MEMORANDUM

Date: December 13, 2021
To: Kathy Smith, P.E., PTOE, HDR Engineering
CC: Nazlie Saeedi, P.E., Bryan Golden, Jayesh Dongre
Austin Transportation Department
Kate Clark, Housing and Planning Department
Reference: Statesman PUD – 305 S. Congress
Transportation Impact Analysis Final Memo
C814-89-0003.02

Figure 2: Mitigation Map

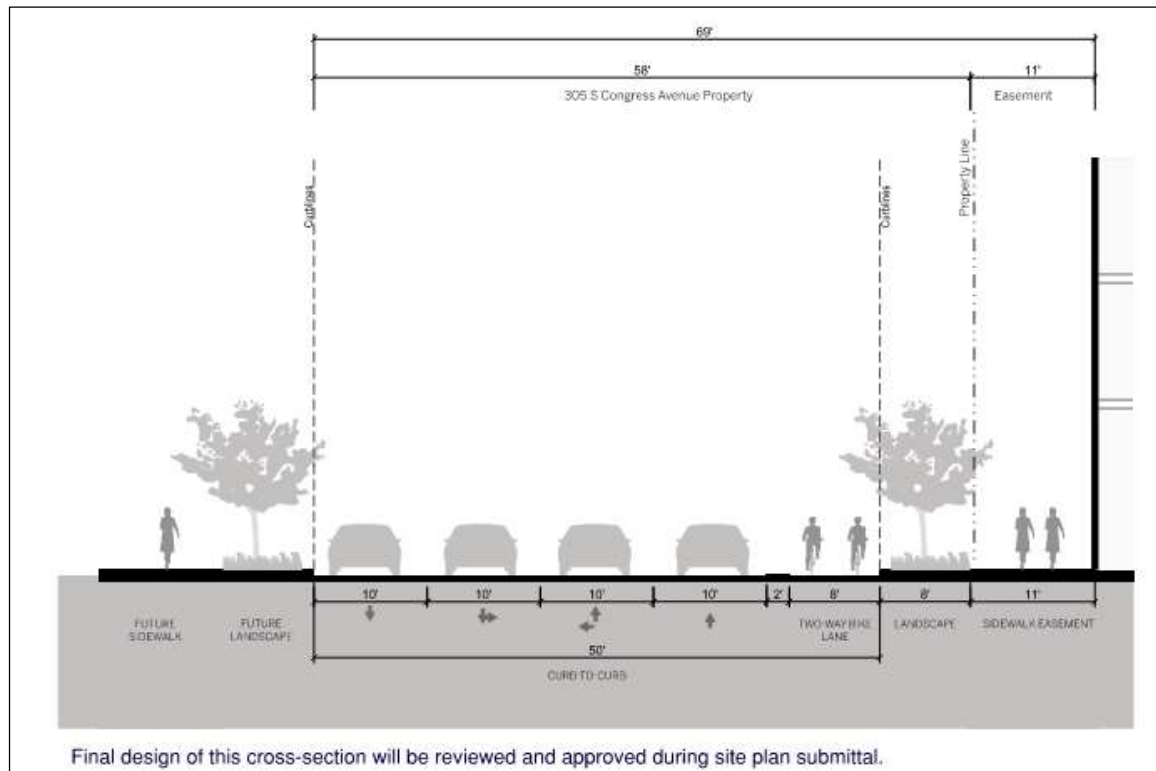
1. The applicant shall design and construct the improvements identified in Table 2 below and in Figure 2 prior to issuance of a temporary certificate of occupancy (TCO) or certificate of occupancy (CO) for the first building requiring a CO.
2. The applicant shall dedicate, design, and construct the Barton Springs Extension prior to the issuance of the **first** temporary certificate of occupancy (TCO) or certificate of occupancy (CO) for the first building requiring a CO. The Barton Springs Extension will be constructed by this development in accordance with the PUD ordinance, as shown in Figure 3.
3. The applicant shall incorporate bicycle and pedestrian facilities along the Riverside Drive Access with construction of the Barton Springs Extension which will be with the first building requiring a CO, subject to ATD approval.

4. At the time of first building permit, the following must be submitted for ATD's review and approval: the design of the Barton Springs Extension, the design of the westbound receiving lane at Barton Springs Rd and S. Congress Ave, the design of the bicycle and pedestrian facilities along the Riverside Drive Access, show compliance with the approved overall TDM reduction of 35 percent, and cost estimates for the improvements in Table 2.
